METROPOLITAN GOVERNMENT OF NASHVILLE AND DAVIDSON COUNTY

STAFF RECOMMENDATION
1404 Clayton Avenue
August 15, 2012

Application: New construction—addition
District: Belmont-Hillsboro Neighborhood Conservation Zoning Overlay
Council District: 18
Map and Parcel Number: 11708016500
Applicant: Keith Dowd
Project Lead: Melissa Baldock, melissa.baldock@nashville.gov

Description of Project: Application is to construct a two-story rear addition that is taller than the one-story historic structure. The project also involves re-cladding a previously enclosed side porch. No changes are currently planned for the existing rear accessory structure.

1404 Clayton, rear façade.

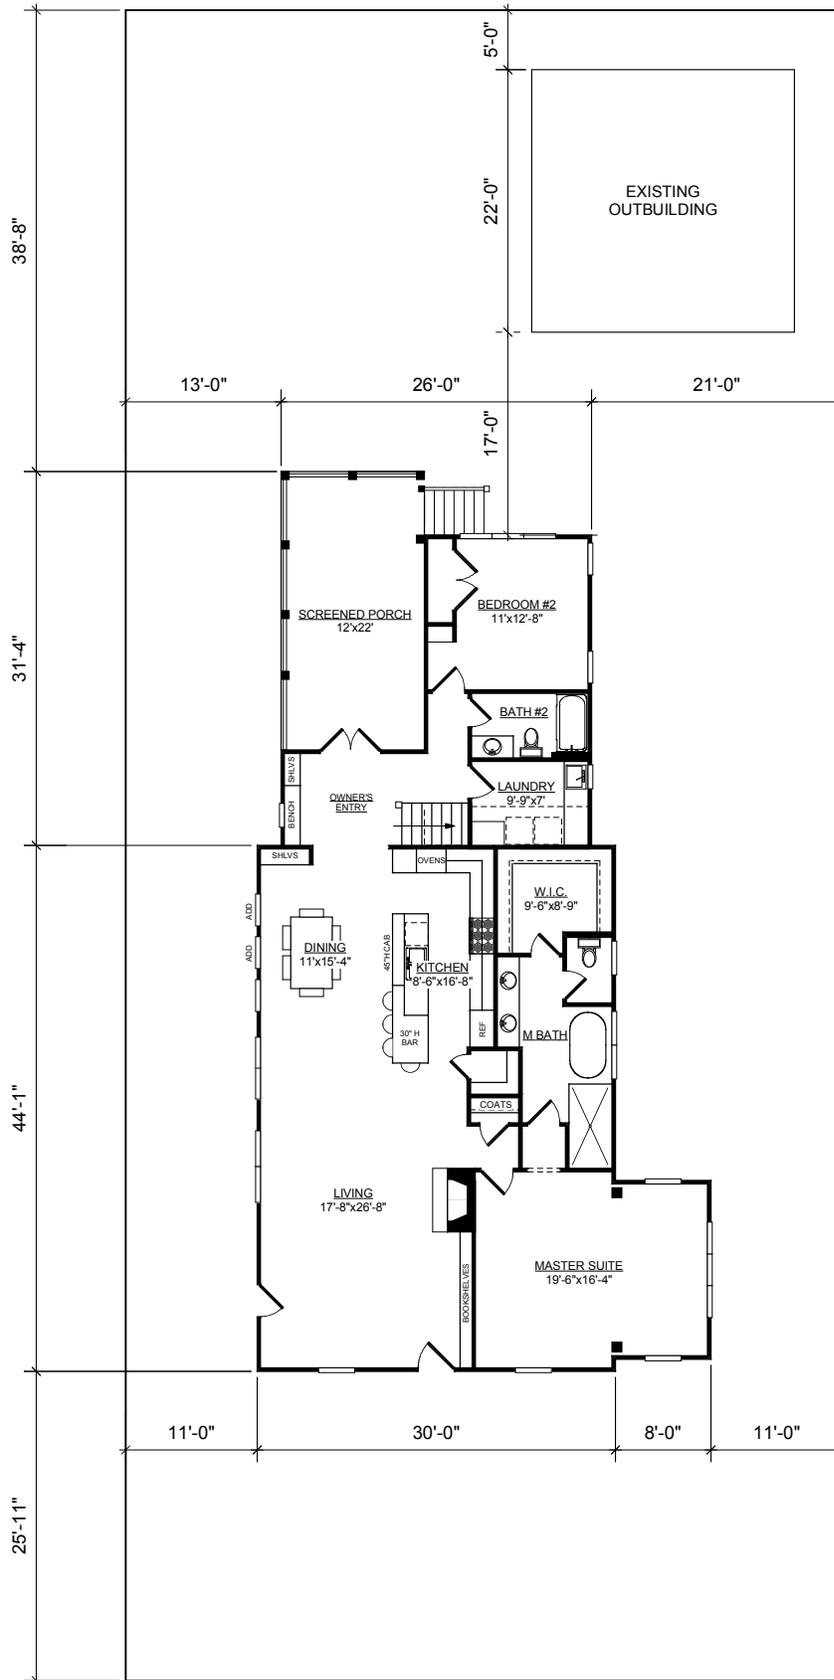
Application is to construct a two-story rear addition that is taller than the one-story historic structure. The project also involves re-cladding a previously enclosed side porch. No changes are currently planned for the existing rear accessory structure under this application (see photo below).

The application does not include plans to demolish, rebuild or expand the existing accessory structure.

LEFT ELEVATION

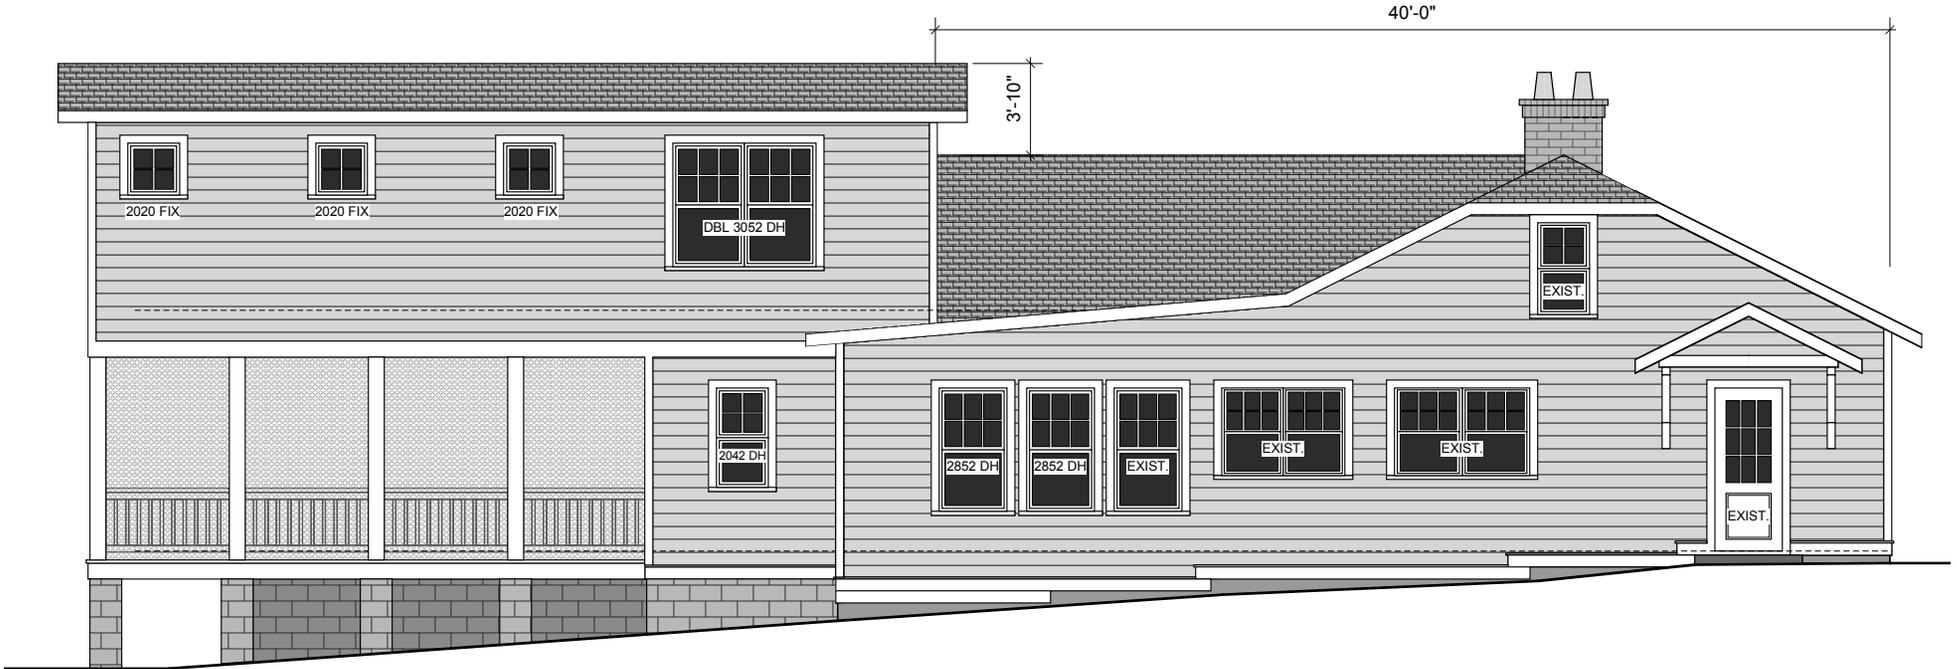
The two side elevations show that the addition will be a total of three feet, ten inches (3'10") taller than the house, but the front elevation indicates that the addition will be approximately four feet, six inches (4'6") taller. Staff asks that a condition of approval be that the addition be no more than three feet, ten inches (3'10") taller than the historic house and that the applicant submit a revised front façade drawing reflecting this height.

The addition meets most, but not all, of these criteria. The addition is inset two feet (2') from the sidewalls of the house, is less than four feet (4') taller than the historic house, and does not gain in height until forty feet (40') behind the front wall of the house. However, the addition has a front-facing gable portion that does not meet the design guidelines. Staff asks that a condition of approval be that the front-facing gable portion of the addition have a clipped gable, and that its eave height be lowered to match the eave

The taller portion of the addition has two roof forms. On the left side is a front-facing gable roof that extends from the front of the addition to the rear. As was mentioned previously, staff asks that this portion of the addition have a clipped gable roof, at least at the front, and that its eave height be reduced to match the eave height of the other portion of the addition (i.e. lowered by approximately nine to twelve additions (9"-12")). On the right side of the taller portion of the addition is a gable with a slope of 3/12. A wall dormer is proposed for the rear façade. Although wall dormers are generally discouraged, staff finds this wall dormer acceptable because it is on the rear façade and will not be visible.

heights of the remaining portion of the addition (i.e. lowered by approximately nine to twelve additions (9"-12")). With these changes staff finds the addition's height to meet the design guidelines.

1. The applicant submit a new front façade elevation showing that the addition will only be three feet, ten inches (3'10") taller than the existing house.
2. The front-facing gable portion of the addition have a clipped gable.
3. The eave height of the front-facing gable portion of the addition be lowered by approximately nine to twelve inches (9" – 12") to match the eave height of the remaining portion of the addition.
4. Four to six inch (4" – 6") mullions be included between all double and triple windows.
5. Staff review and approve the asphalt shingle color and the specifications and materials for all windows and doors.
